YANKEE NUCLEAR POWER STATION (YANKEE-ROWE)

AMENDMENT TO FACILITY OPERATING LICENSE

Amendment No. 54
License No. DPR-3

ATTACHMENT TO LICENSE AMENDMENT NO. 54

Figure 3.2-1

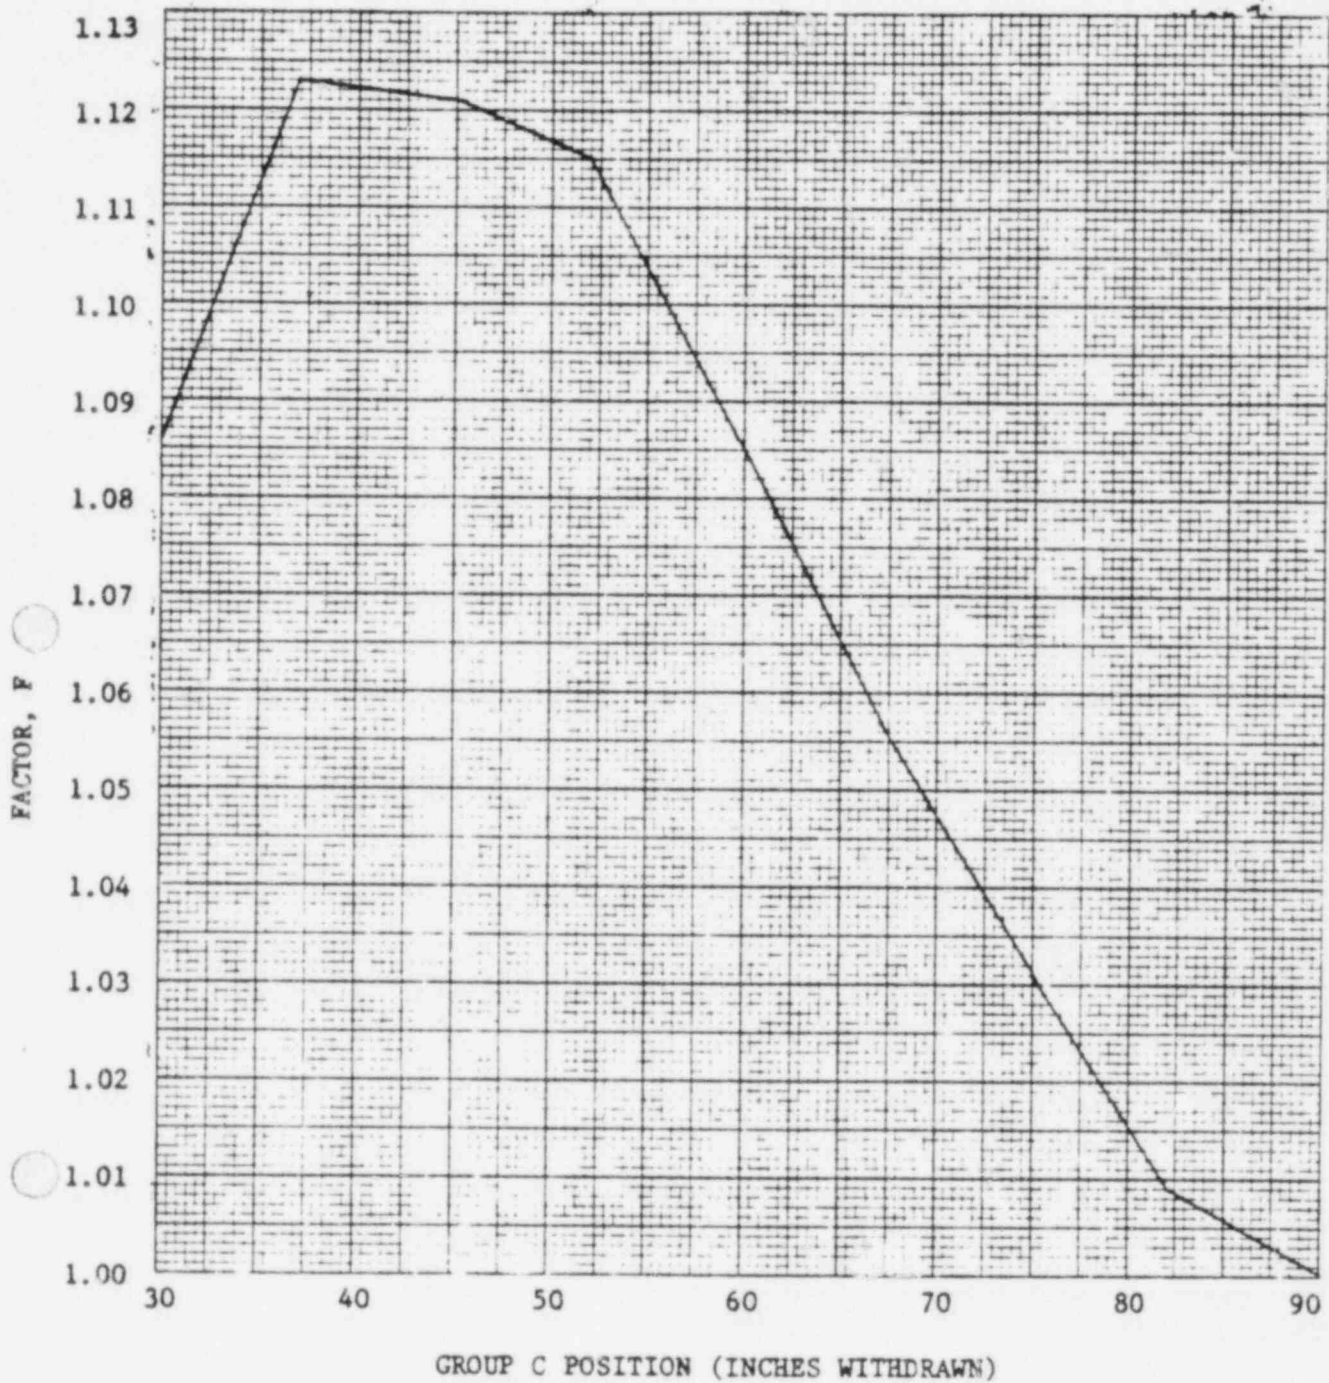
3.2.1 The peak linear heat generation rate (LHGR) shall not exceed the limits of Figure 3.2-1 during steady state operation.*

With the peak LHGR exceeding the limits of Figure 3.2-1;

4.2.1.1 The peak LHGR shall be determined to be within the limits of Figure 3.2-1 using incore instrumentation to obtain a power distribution map:

Figure 3.2-4

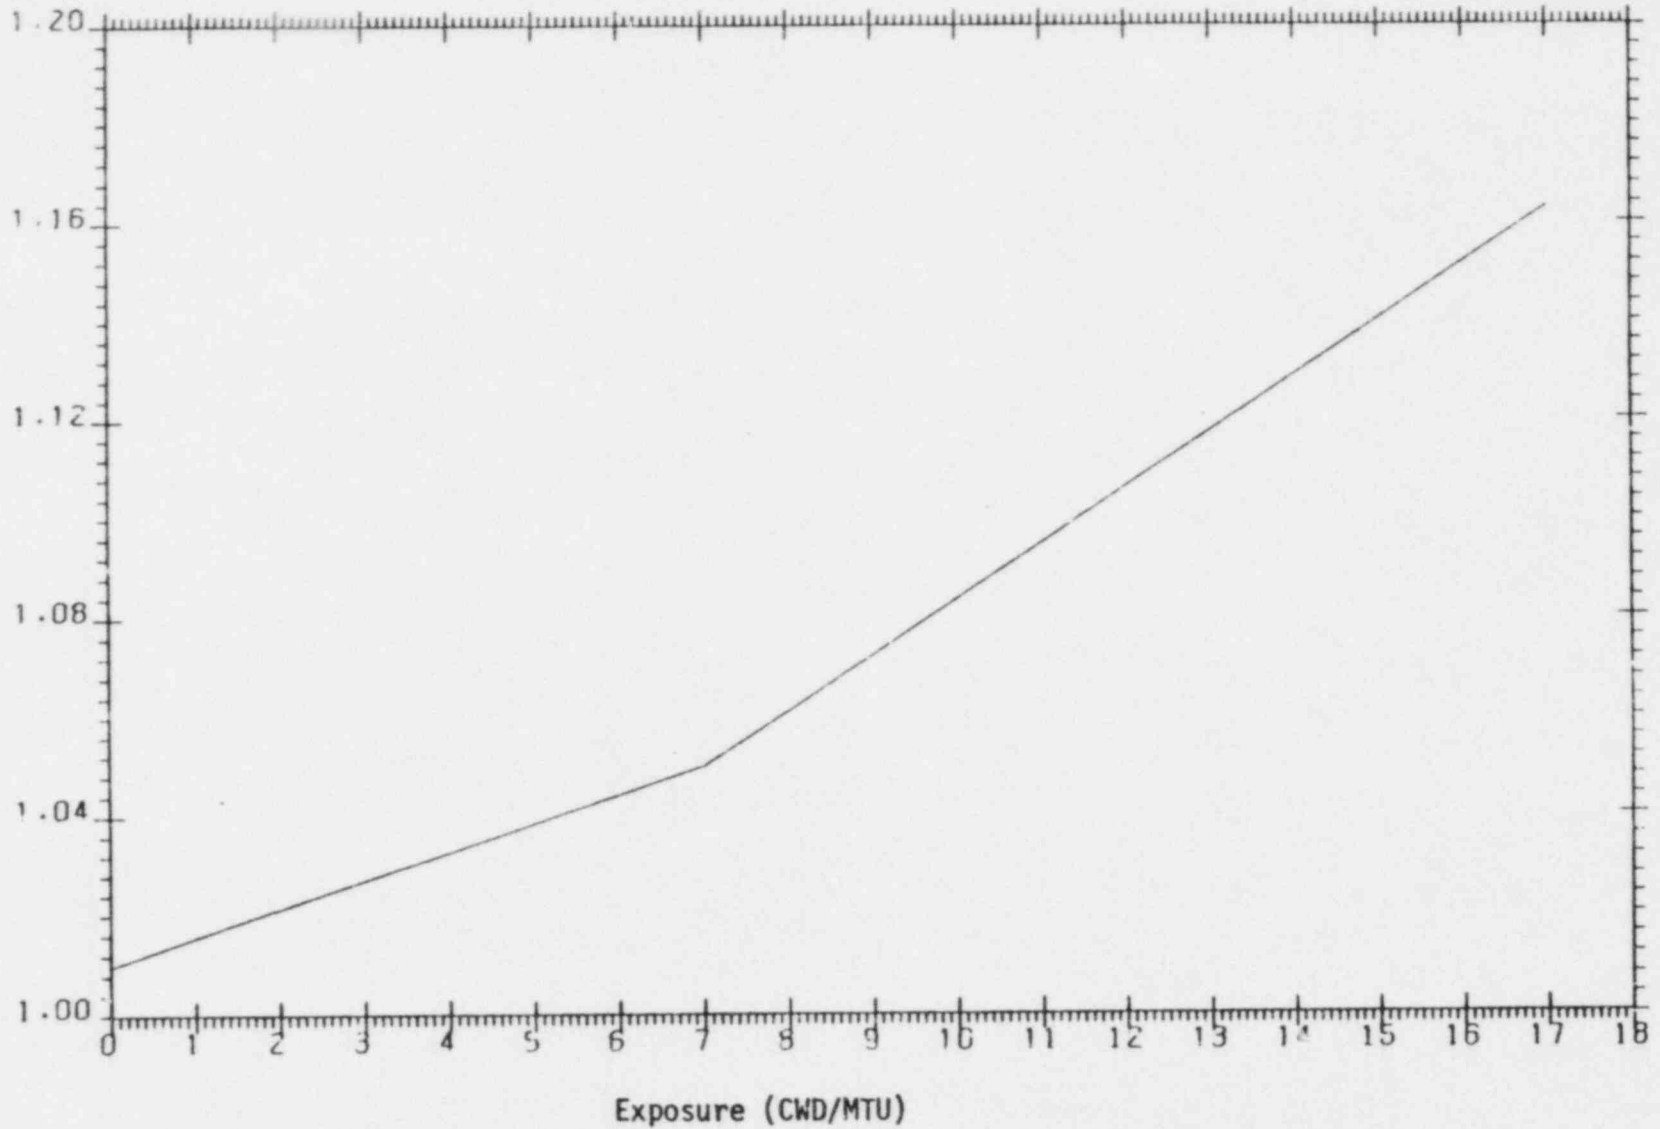
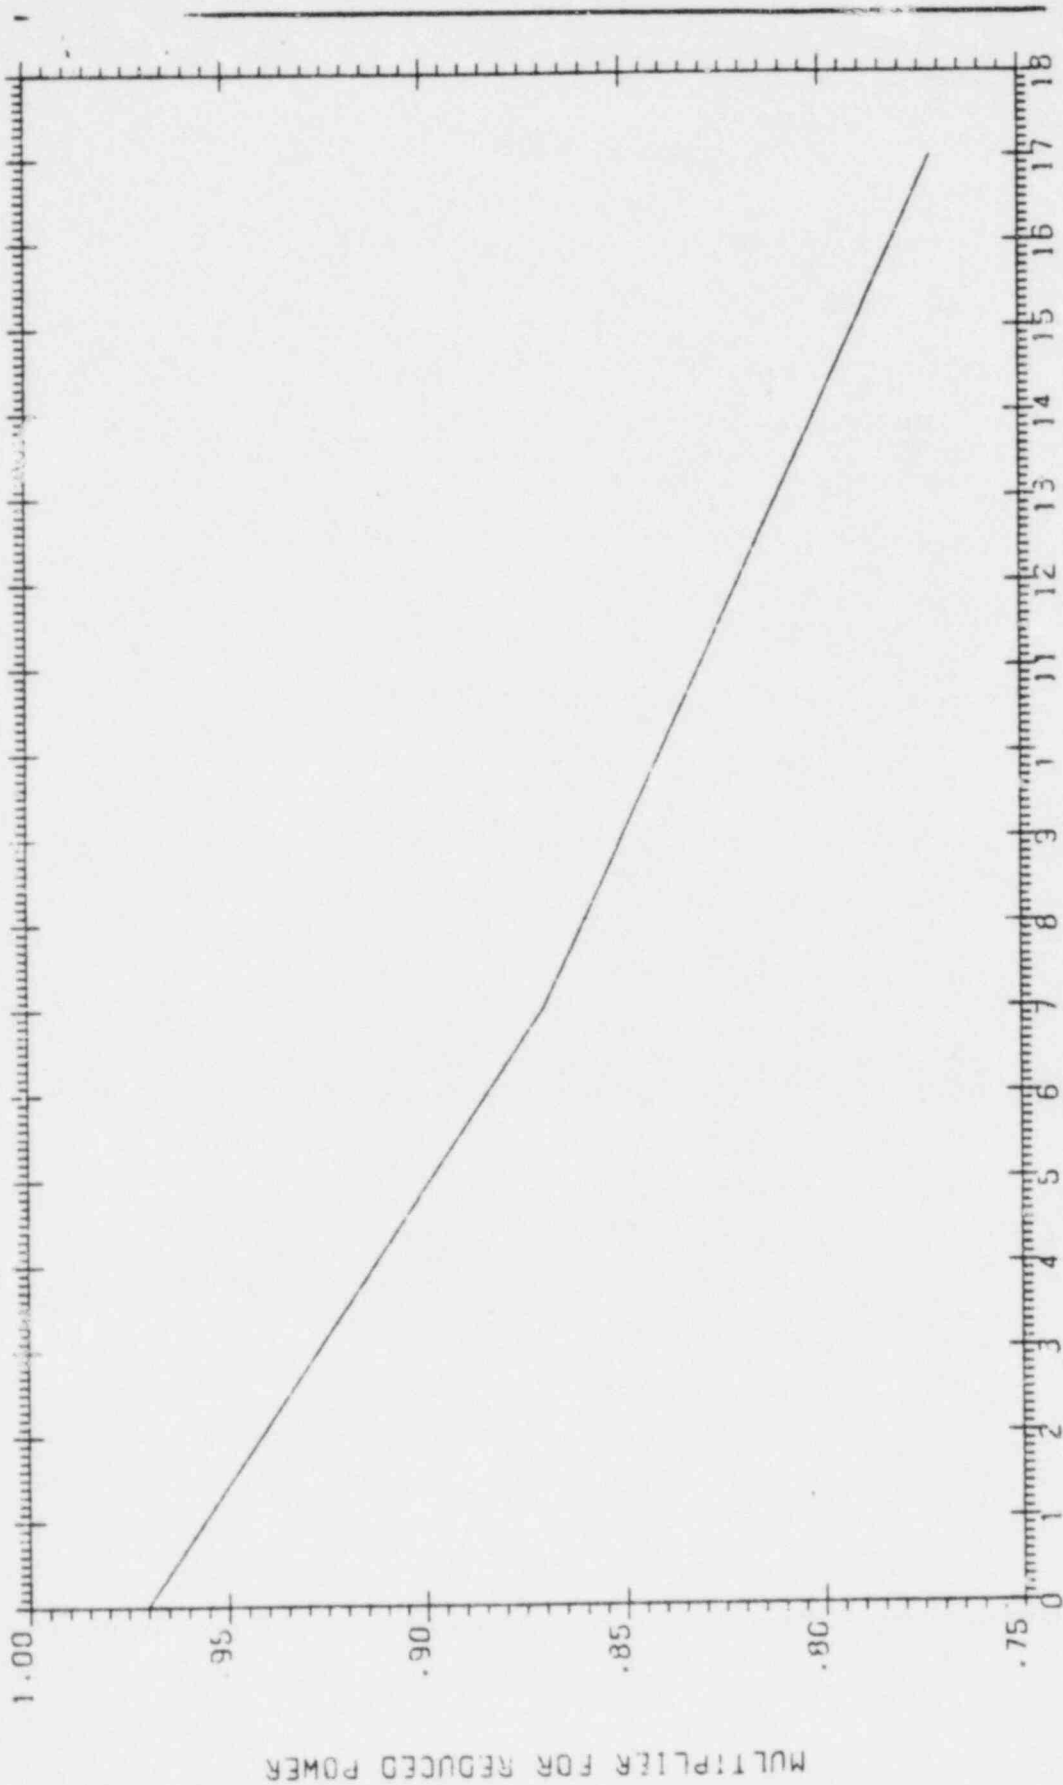
Reduced power = allowable fraction of full power times multiplier given in Figure 3.2-4.
